AGENDA

Architectural Review Board

April 24, 2018

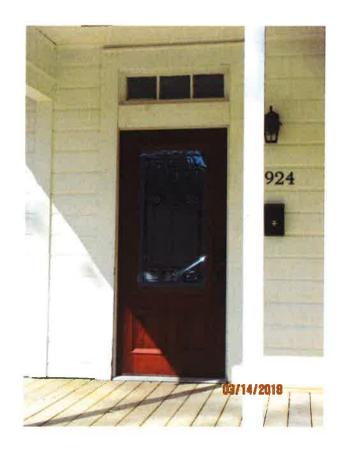
- The Board previously approved the same door for 106 South Capitol Parkway against staff recommendations. The style is not typical of historic doors in Montgomery. Research indicates that the petition was made at a meeting the staff member was not present for, and therefore could not frown at the Board when approving two door options, with a preference to the more traditional door that was not installed.
- One of the photos taken is of a 2/3 glass door with a beveled edged panel that is stained and appears to be original to the house located on a house across the street from the subject property.

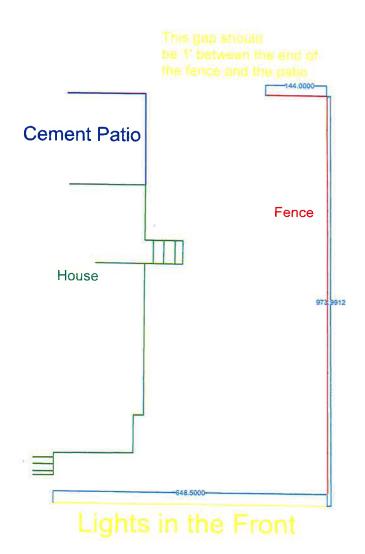
•	The fence is low and will not impact the historic structure. The side of the property where
	the fence is proposed has already been compromised by new development. Staff finds this
	to be a fairly inconspicuous solution to providing a safety barrier and leaving the views
	open.

Blacksmith Reroofing Project

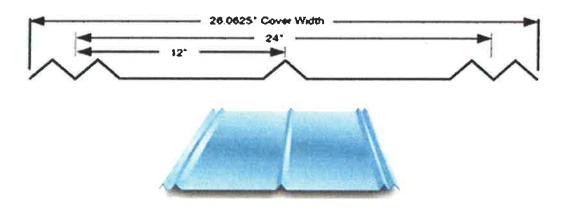
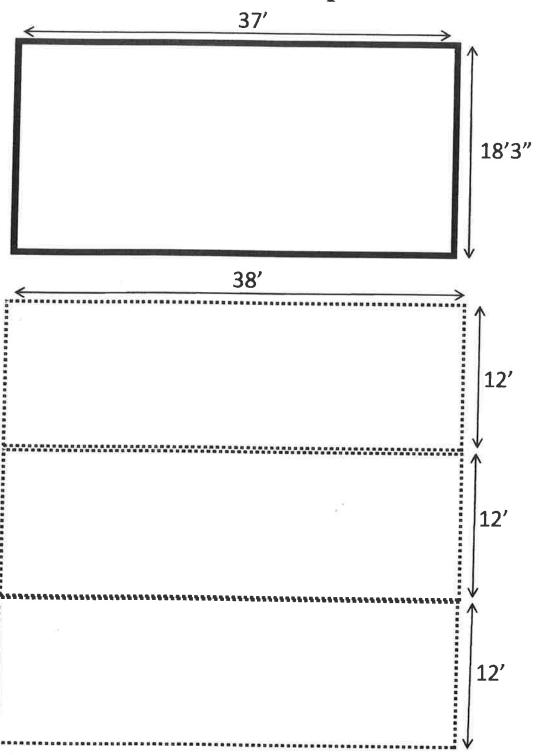
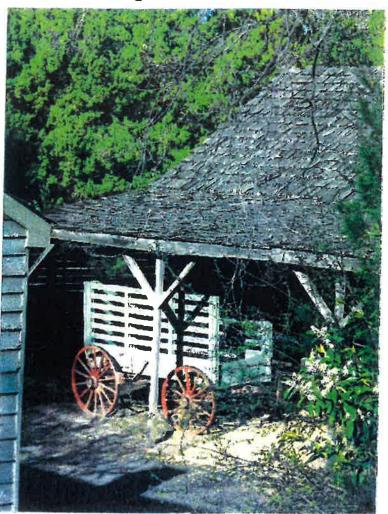
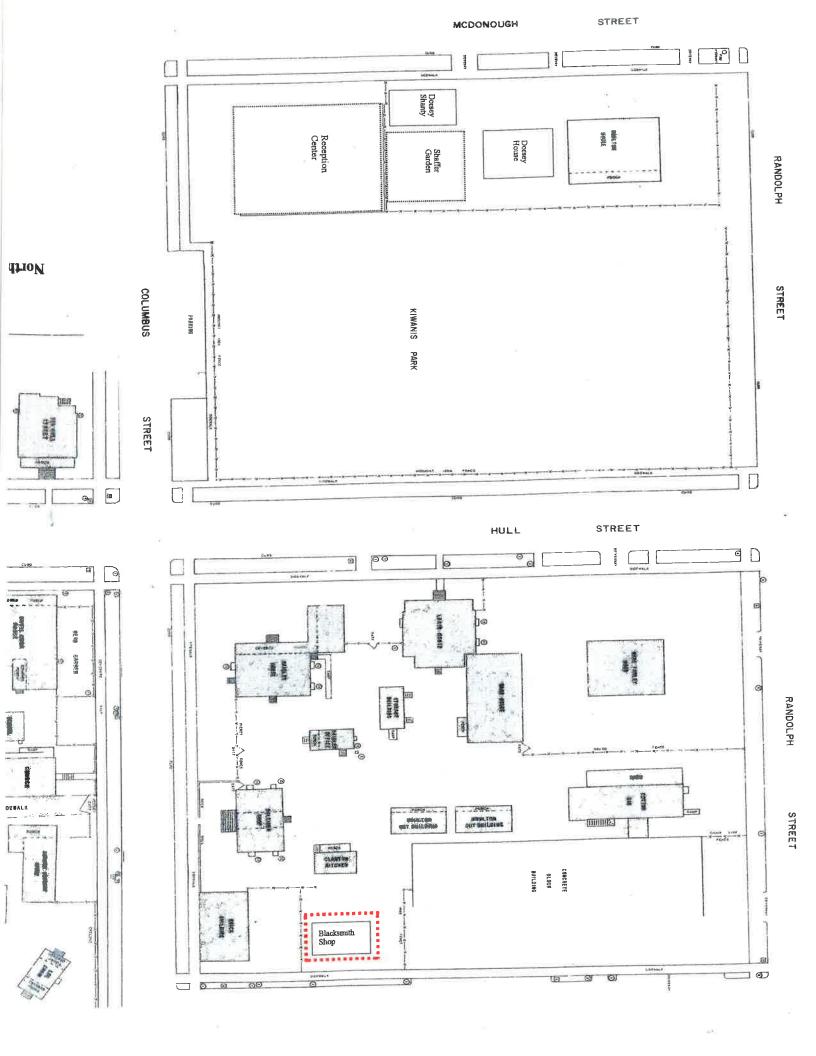
•	In the past the Board has held the interpreted buildings at Old Alabama Town to a higher
	standard. The Board needs to determine if the 5 v-crimp is a good alternative to the cedar
	shingles available now and would be appropriate for what would have been a rural
	outbuilding.

Ordeman-Shaw Reroofing Project

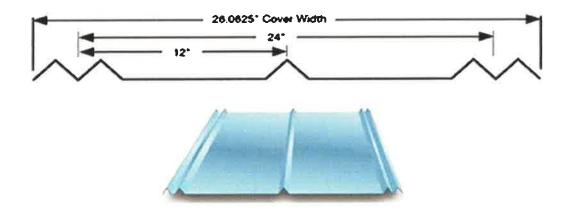
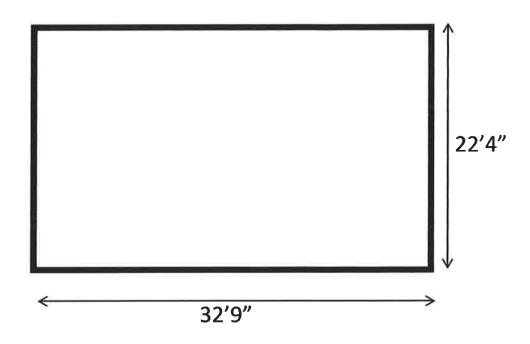
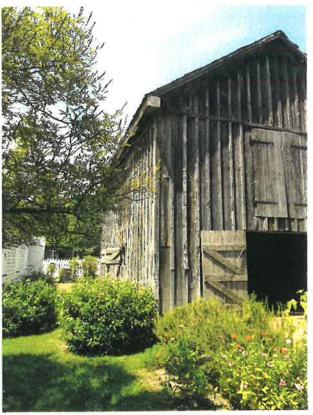
•	In the past the Board has held the interpreted buildings at Old Alabama Town to a higher
	standard. The Board needs to determine if the 5 v-crimp is a good alternative to the cedar
	shingles available now and would be appropriate for the barn.

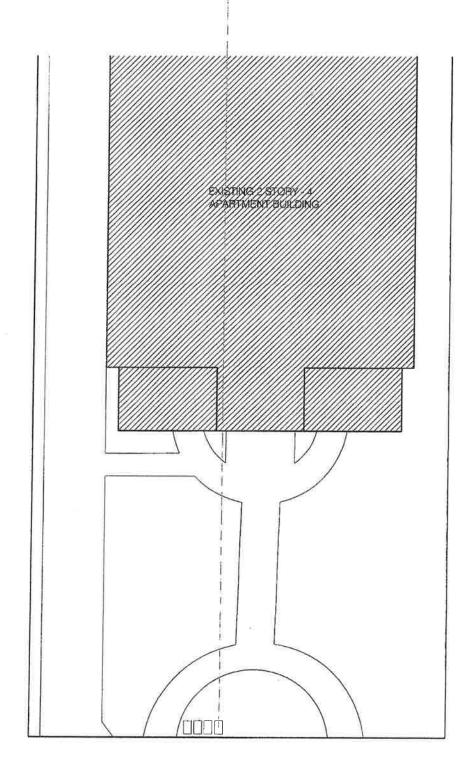
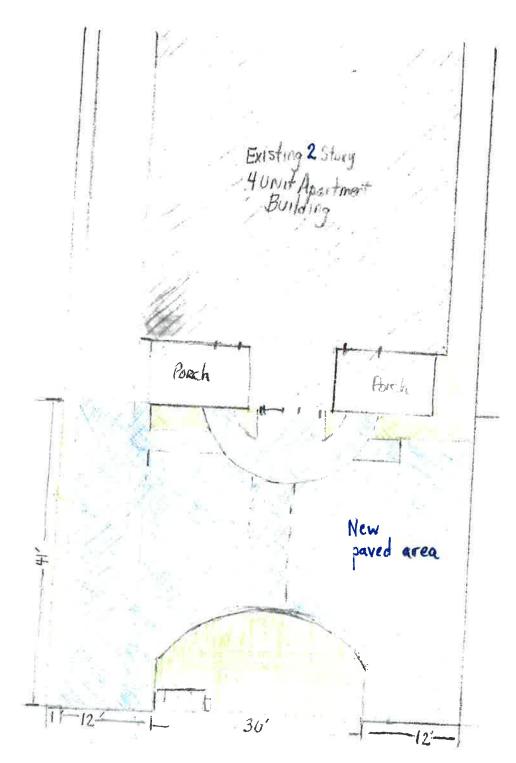
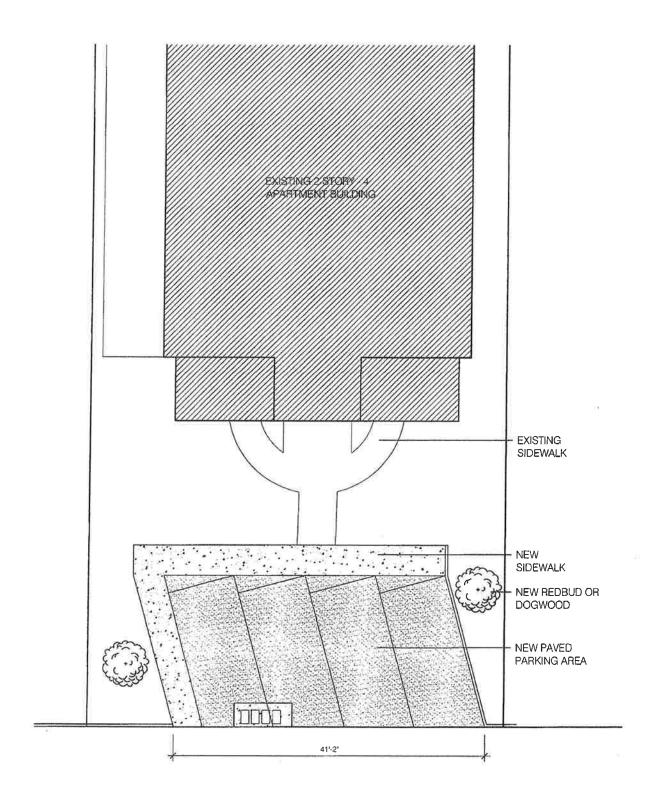
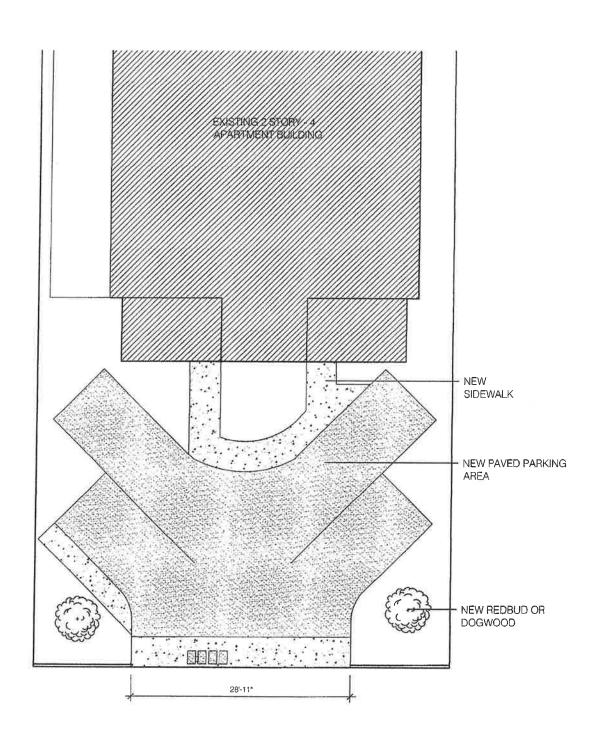
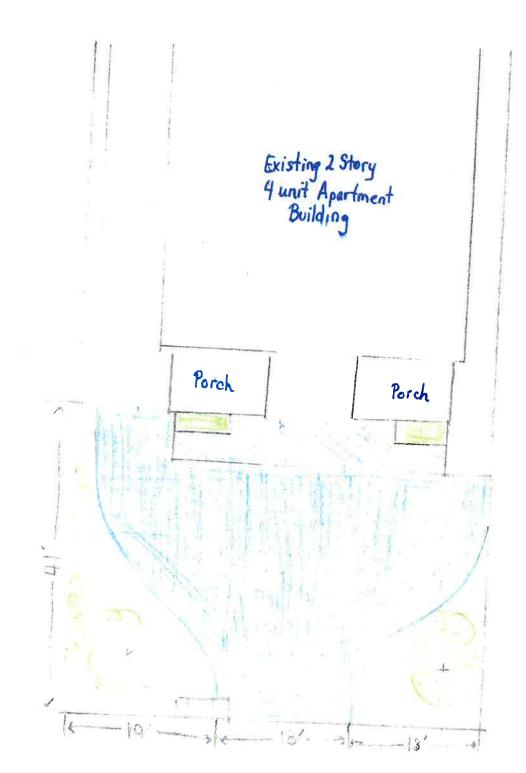
•	Most of the options introduce paving to more than 50% of the front yard. The Board has
	generally required vegetative screens to help soften the appearance of parking surfaces
	from the streetscape view.
	COMMENTS
	ACTION

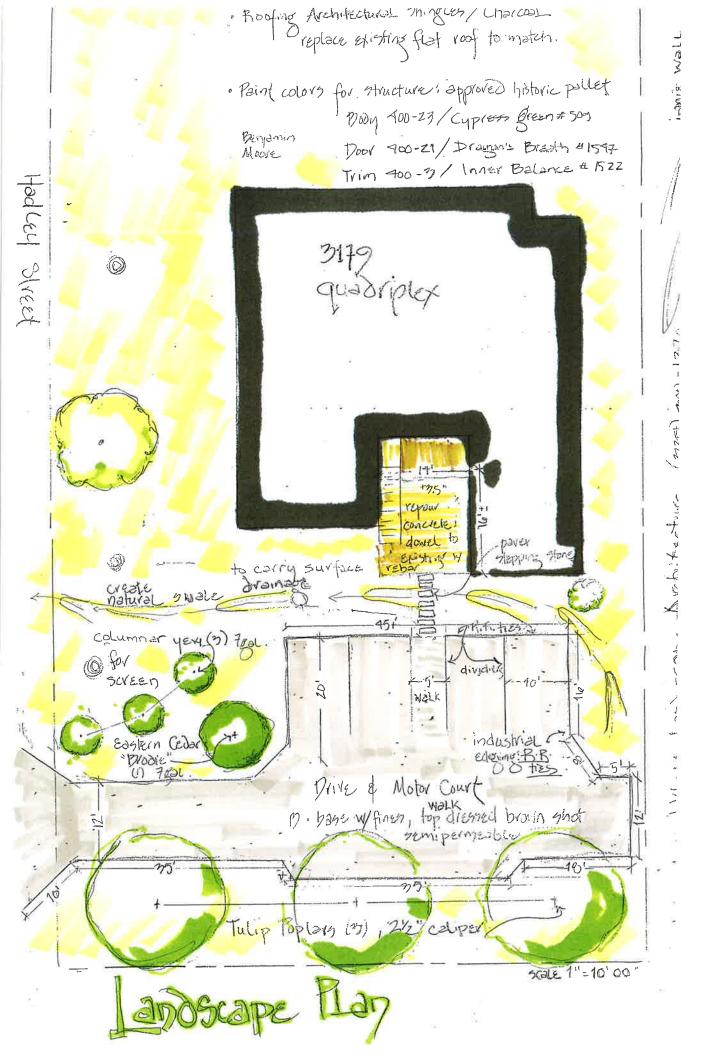
•	The new landscape plan adds 4 plants (3 yew, 1 cedar) but only specifies gallon	size	and
	not the height and size of the plants at installation. Only one cedar is being added.

Proposed South Elevation
one quarter inch equals one fool

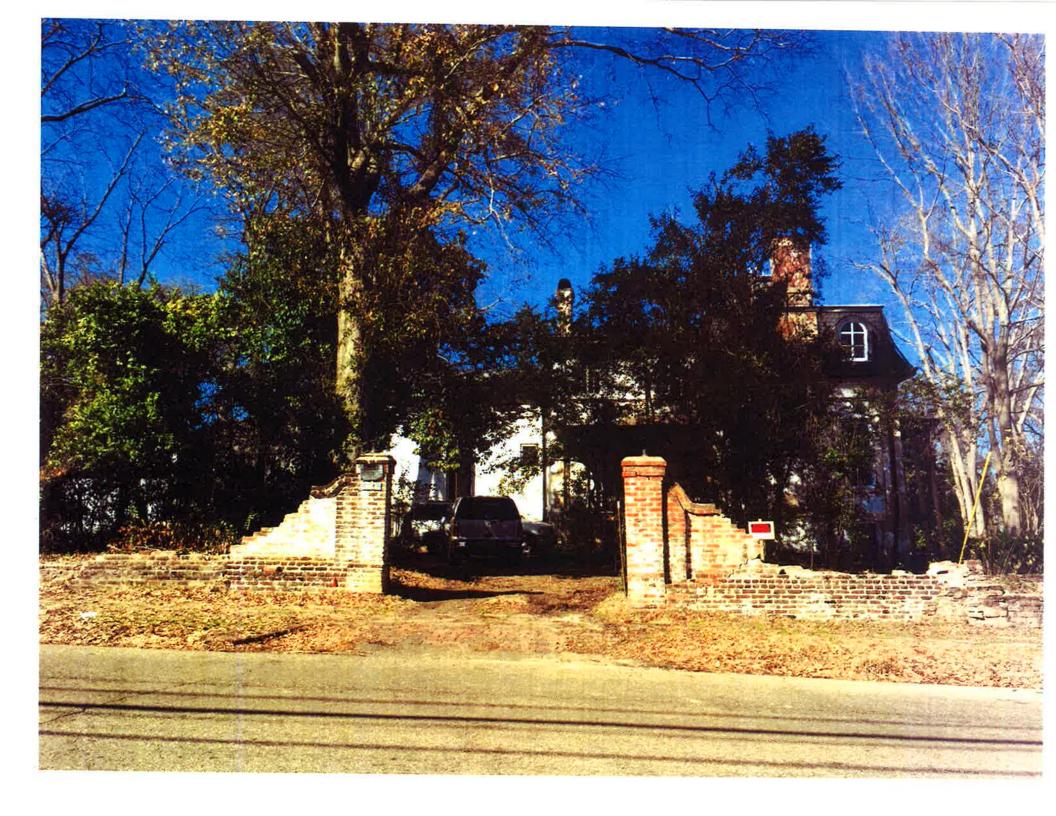
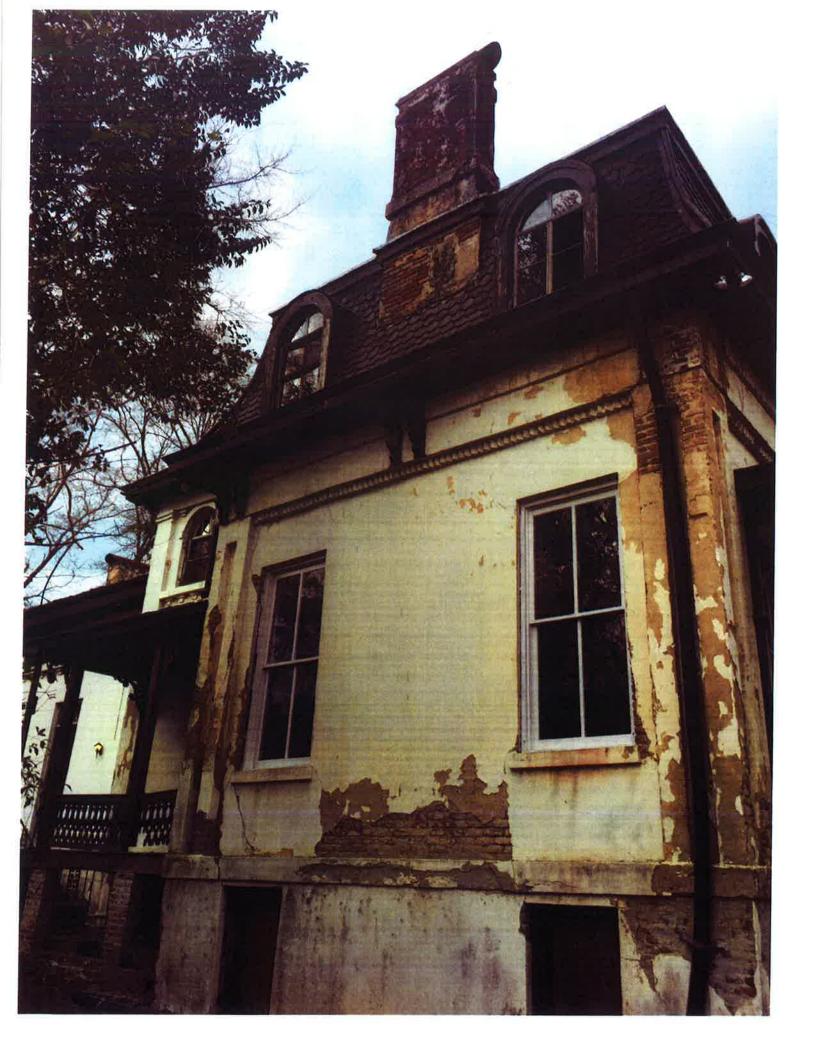
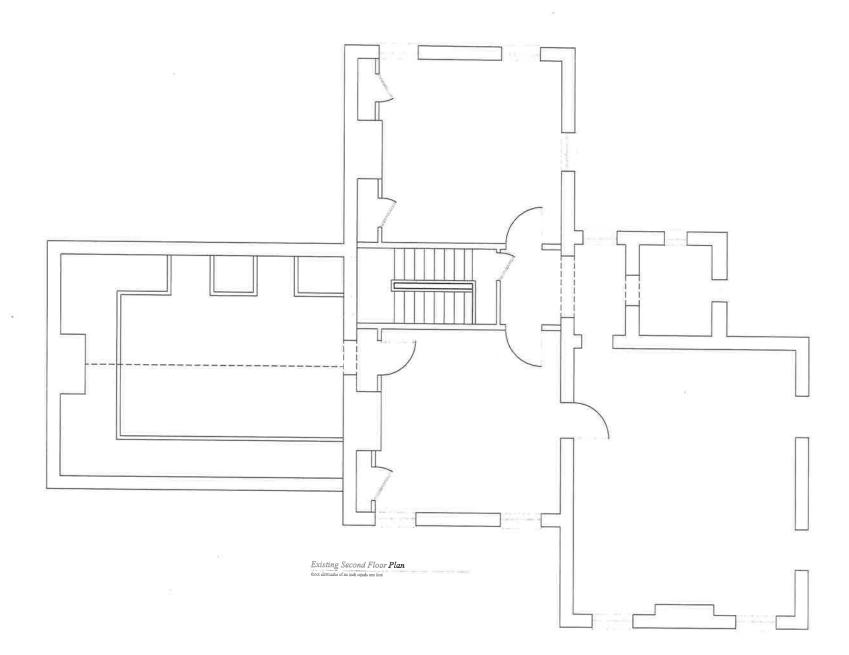
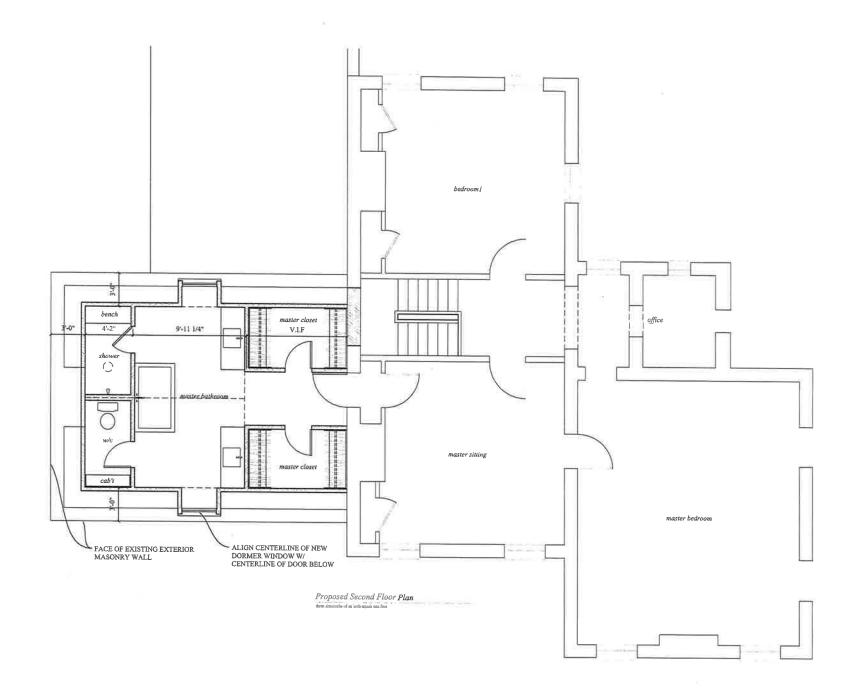
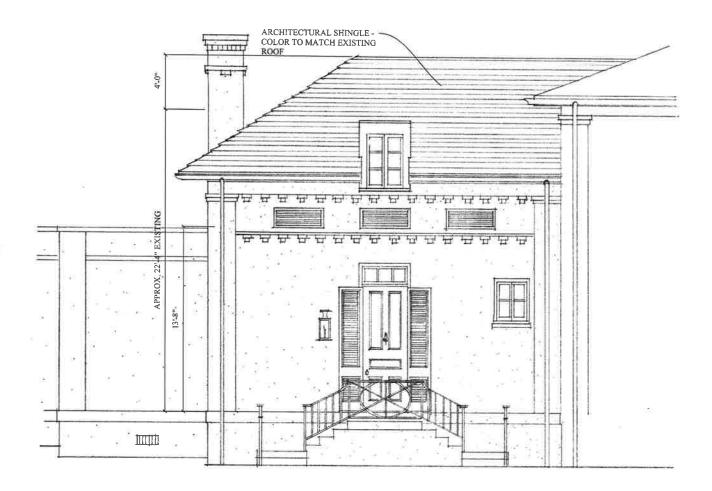
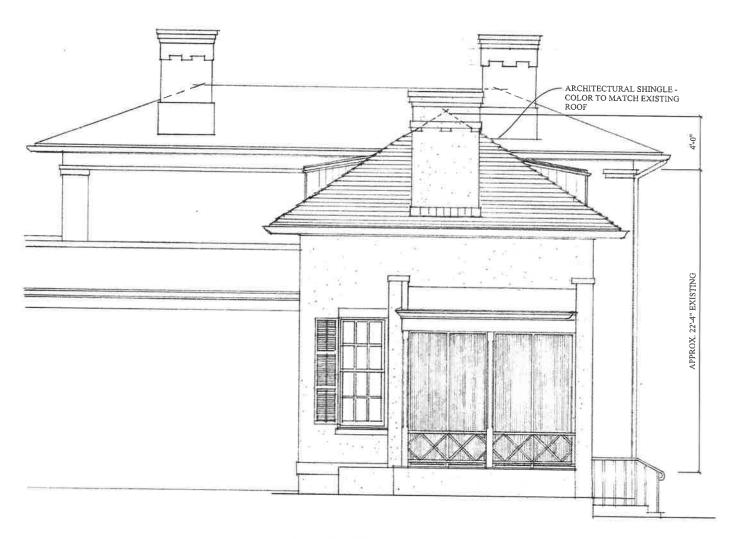
- The Alabama Historical Commission holds an easement on this property and also needs to approve the proposed plan.
- The roof is on a secondary elevation, but would be partially visible from Mildred Street.
